PLAN SNAPSHOT REPORT PA-2026-00058 FOR CITY OF ALBUQUERQUE

Re: Sketch Plat/Plan Submittal – La Curva Multi-family

LA CURVA APARTMENTS

SKETCH PLAT

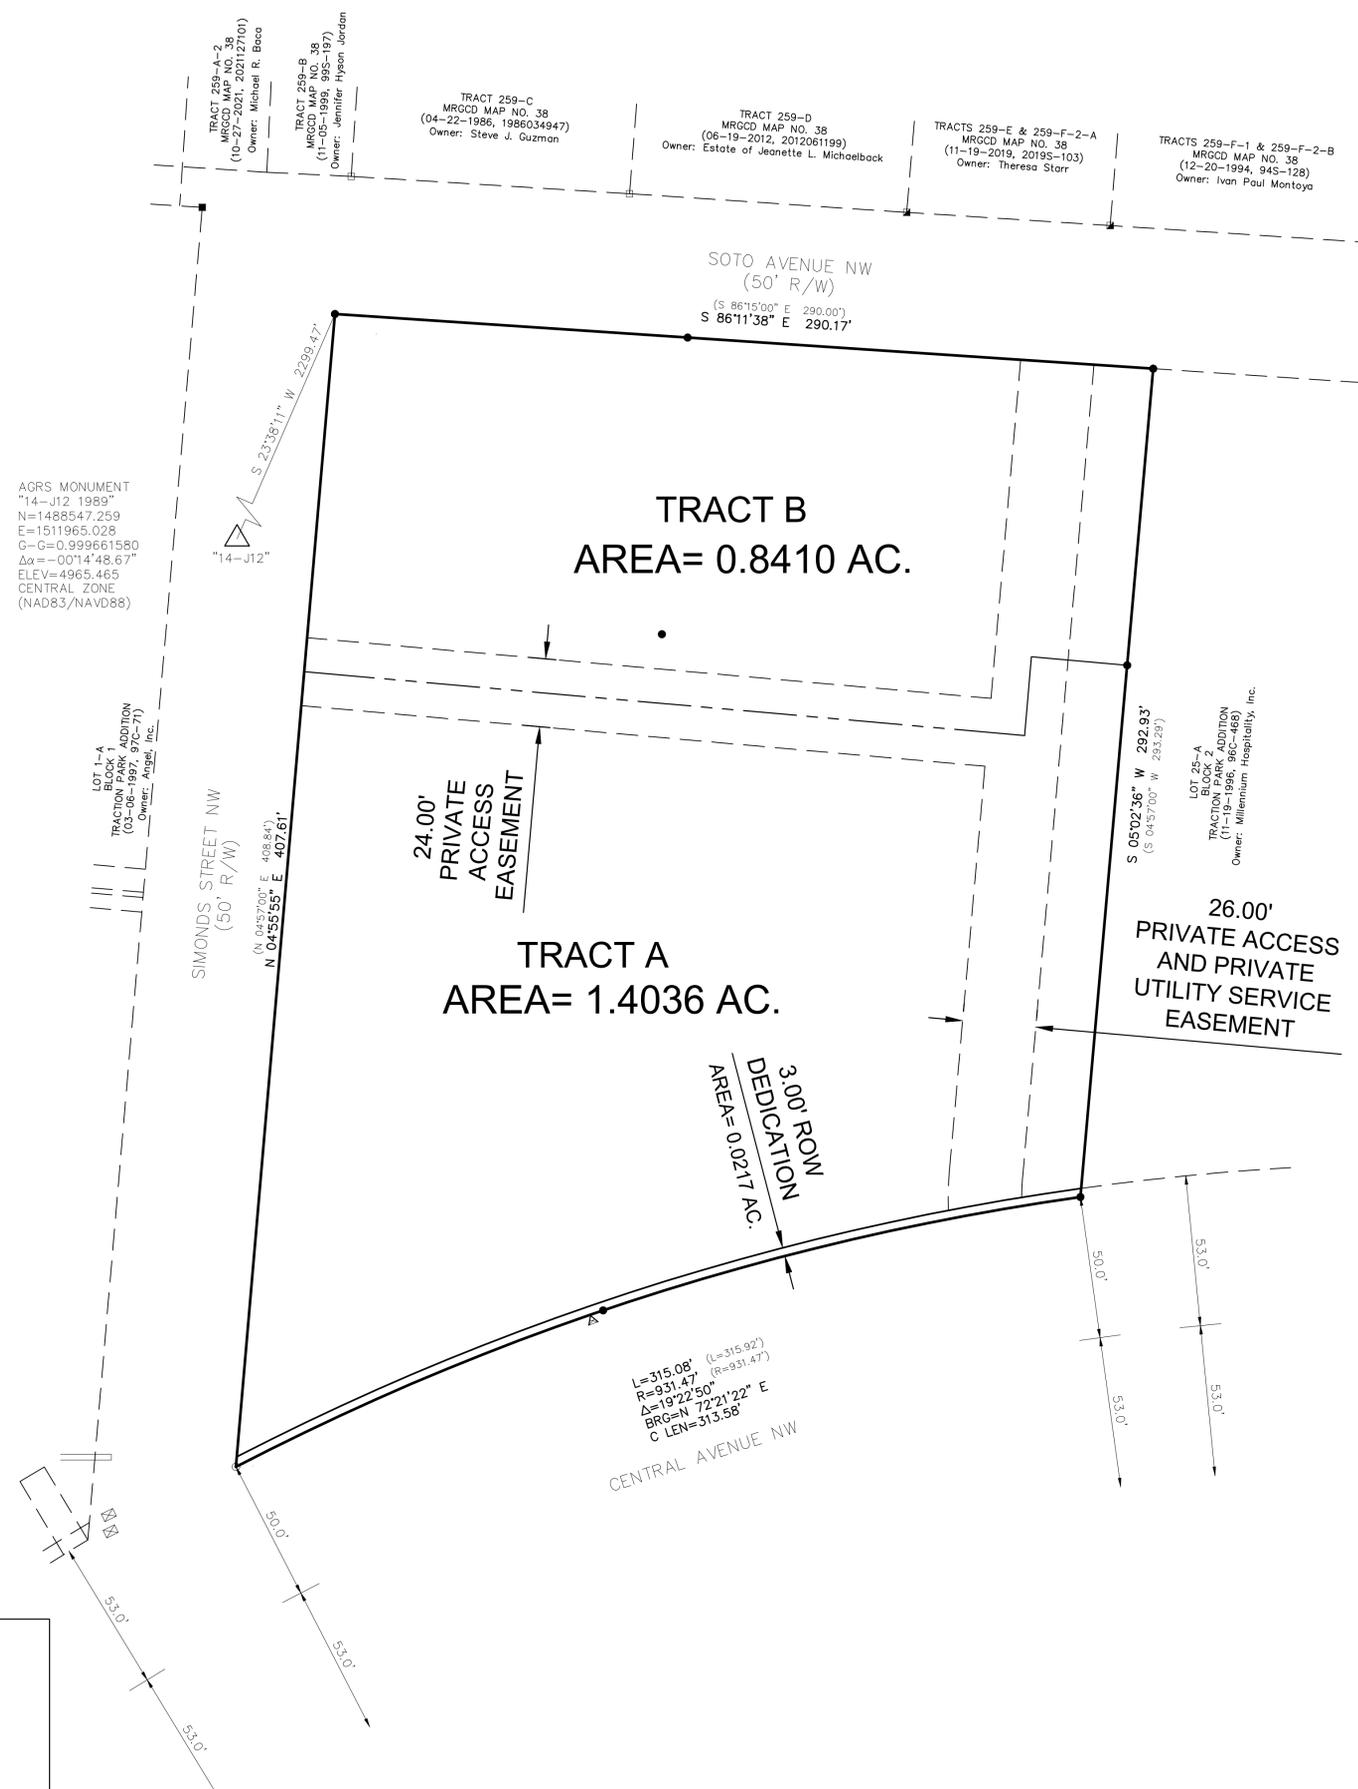
- The Applicant is evaluating the potential vacation of Soto Avenue and Simonds Street and allow a dedicated entrance to the site from the existing Simonds Street curb-cut. The site plan currently shows on-street parking along these two streets. We request guidance on the feasibility of the vacation. A public access easement could be retained.

- Please confirm how the front setback on Central Avenue should be measured where the roadway curves. The setback at the corner of Simonds Street measures 19 feet because of the curvature of the roadway. Can a determination be considered for exceeding the maximum setback?

- Would driveway throat depth requirements change if Simonds Street and Soto Avenue were vacated?
- If the site entrance on Central Avenue were restricted to one-way traffic, can the depth requirement be reduced due to the absence of queuing?

- Please confirm the required drive aisle width for 90-degree parking, given the discrepancy between DPM Table 7.4.78 (24 feet minimum) and Table 7.4.82 (22 feet minimum).

- There is one remaining sign on the property that does not appear to have historic significance. Can this sign be removed as part of the site plan or is there an additional process to remove the sign?

- The IDO does not require EV charging stations for projects under 250 parking spaces. However, we understand that the City will require EV spaces during the building permit process. Please confirm the City's current requirements for EV spaces (ready and fully charged) for this site.
